*RE: Project No. 35077; Informational Filing of ERCOT Interconnection Agreements  
Pursuant to Subst. R. § 25.195(e)*

## **FIRST AMENDMENT TO INTERCONNECTION AGREEMENT**

This FIRST Amendment is made and entered into this 24<sup>th</sup> day of April, 2024 between **Lone Star Transmission, LLC** (“Transmission Service Provider”) and **Longhorn Storage LLC, LLC** (“Generator”), hereinafter individually referred to as “Party,” and collectively referred to as “Parties.”

## Exhibit “C” Interconnection Details

### Point of Interconnection Detail

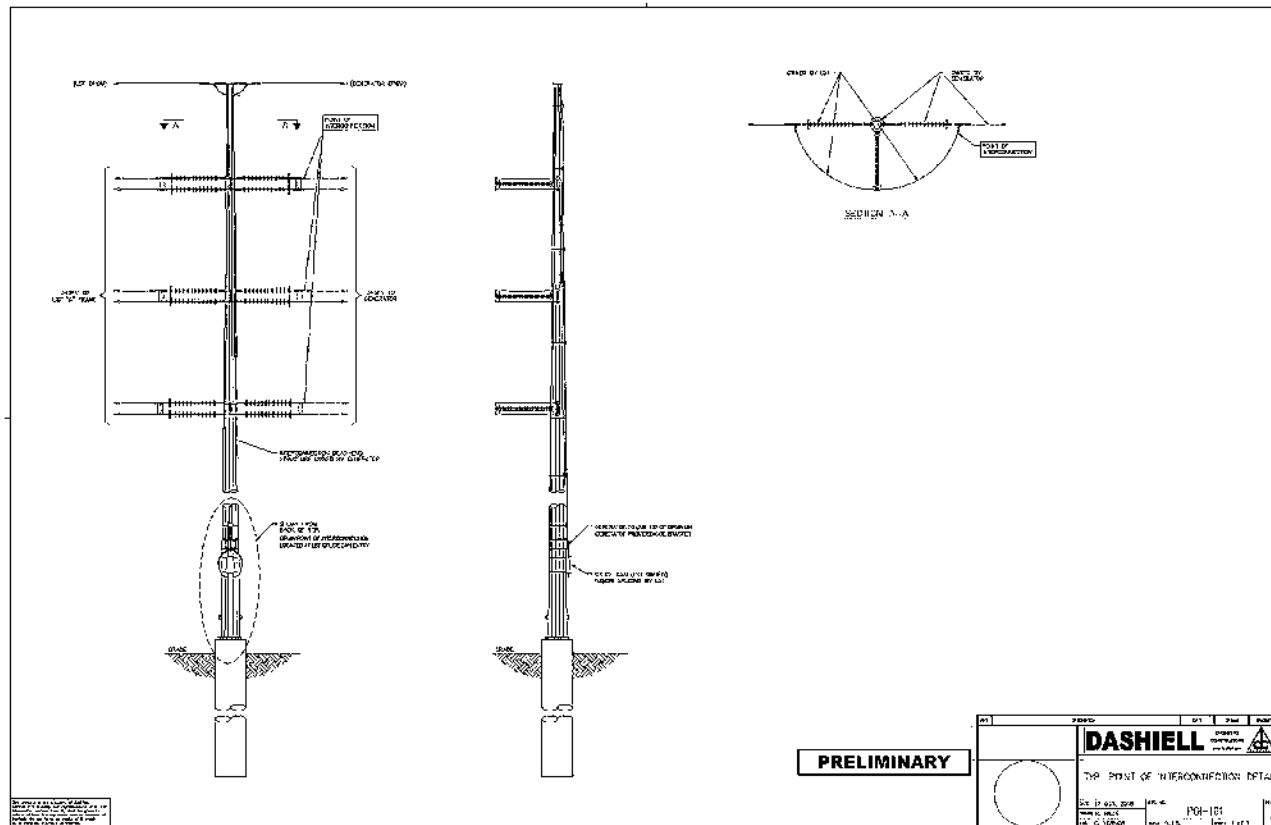
**WHEREAS**, the Generator desires to make a certain change to number of inverters noted and the security arrangement details in the Agreement;

3. Delivery Voltage: 345 kV
4. Number and Size of Generating Units: The total capacity of Sheep Creek Storage is 142 MW at the low side MPT bus under full lagging scenario and excluding any load. Sheep Creek Storage is composed of 41 Sungrow 4.0 MVA Power Conversion Units and 82 Sungrow 2.236 MW Battery Containers.
